**Re: FC-8071, Explosive Detection System Recapitalization
and Optimization at Hartsfield-Jackson Atlanta International
Airport**

Addendum No. 2

MODIFICATIONS ARE INDICATED IN BOLD ITALIC FACE TYPE
PROJECT NUMBER FC-8071 – EXPLOSIVE DETECTION SYSTEM (EDS) RECAPITALIZATION AND OPTIMIZATION – DOMESTIC NORTH TERMINAL

Overall Plan North Terminal Block
01
 Jackson-Medgar Evers International Airport

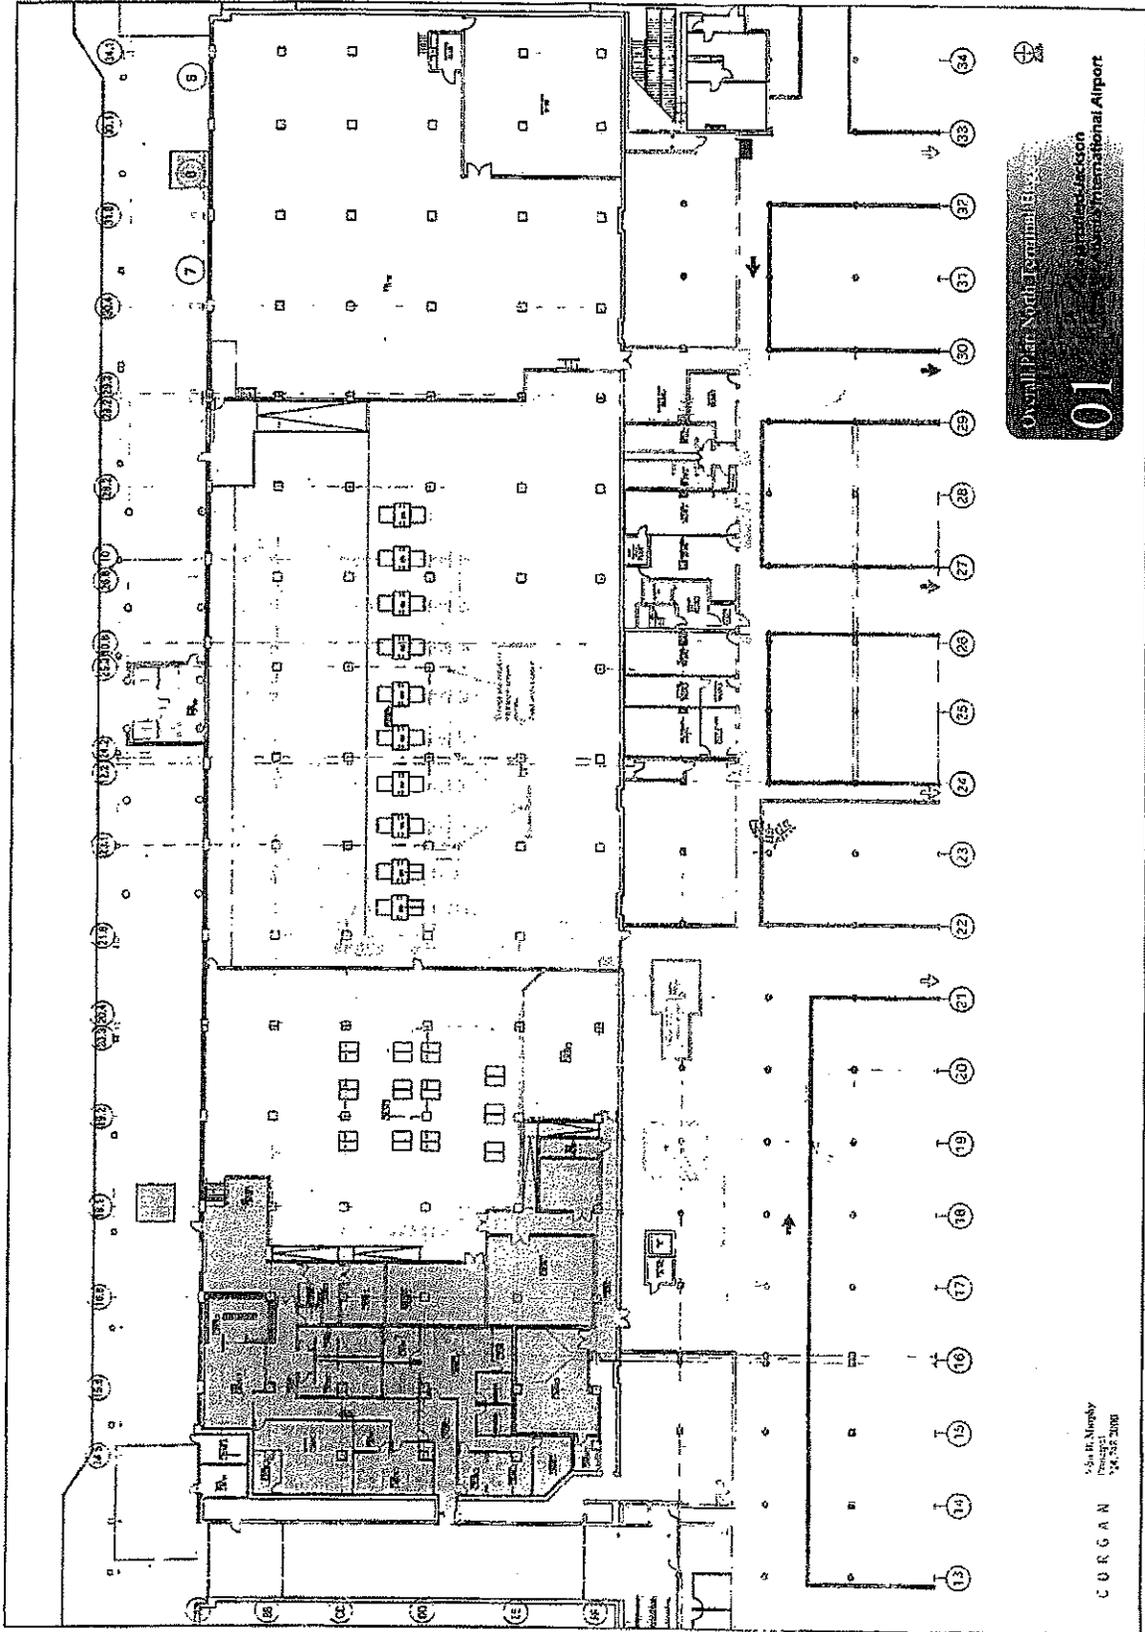
29.	Question:	347716 page 5 1.1.H 27. Update of the remote touch screen BHS controls interface located on the ISD crossovers. If this interface does not exist in the north CBIS, provide uniformity. Continue to utilize the existing HMIs on catwalk, manual encode and other areas as required. Match existing equipment with equal or better equipment, subject to the Owner's approval. Does this interface exist? How many HMI's, manual encode and other areas are there?

32.	Question:	347716 page 6 g. The upper level computer control systems will be replaced to provide complete new sort control, system monitoring and system reporting features for the terminal. New manual encoding stations will also be installed to replace the existing system. Conflict - This is not identified in the drawings. Please clarify if drawings or spec is followed.

Answer:	<i>Add one (1) remote touch screen control interface in central location on catwalk above the CTX machines. Update HMI's at Manual encode locations near BHS Control Room. There are two (2) stations at the manual encode location. See attached drawing for locations.</i>

Answer:	<i>The new sort control, system monitoring, system reporting features for the North Sortation system and the manual encode station are to be programed with the new Brock Controls. An attached drawing shows the location of the main BHS control Room and the Manual Encode station.</i>
